Service Bulletin

SB-10059104-2987

SUBJECT: Service Update for Inventory and Customer Vehicles
Transfer Case Adapter Missing Lower Bolts
Expires with Base Warranty

MODELS: 2015 Chevrolet Colorado 4WD
2015 GMC Canyon 4WD
Equipped with 2.5L Engine (RPO LCV) and 6-Speed Automatic
Transmission (RPO MYB)

4135343

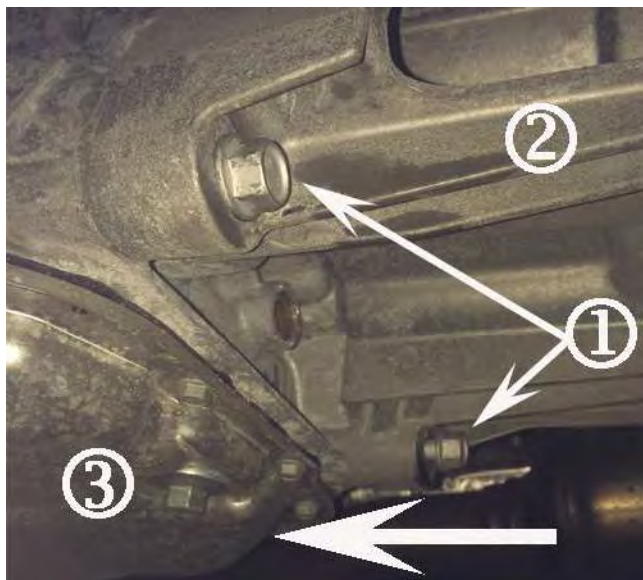
This bulletin provides a service procedure to install two bolts onto the transfer case adapter housing on **certain** 2015 model year Chevrolet Colorado 4WD and GMC Canyon 4WD vehicles equipped with a 2.5L engine (RPO LCV) and a 6-speed automatic transmission (RPO MYB). These vehicles may be missing two lower transfer case adapter bolts. This could cause increased vibration at vehicle speeds above 80 mph (128 km/h). CAE analysis shows that there will be increased stress levels to the transmission housing, bell housing, and adapter housing. If a vehicle with this condition also has a severely imbalanced driveline and is operated at high vehicle speeds for a long period of time, these increased stress levels could lead to cracks in the transmission housing, bell housing, and adapter housing. If cracks occur, the vehicle could leak transmission fluid. With enough fluid loss, the "Check Engine" light will illuminate. Additionally, if the adapter housing develops a circumferential crack, the vehicle could suddenly lose propulsion.

Note: The adapter is bolted to the transmission with six fasteners inside the adapter housing. Threading in the two lower external bolts may meet with some resistance. If needed, gradually thread bolts in/out before final torquing to ensure complete seating of fasteners.

2. Install the two transfer case adapter lower bolts (1) through the adapter (2) and into the transmission (3).
3. Torque the bolts to **58 Nm (43 lb-ft)**.
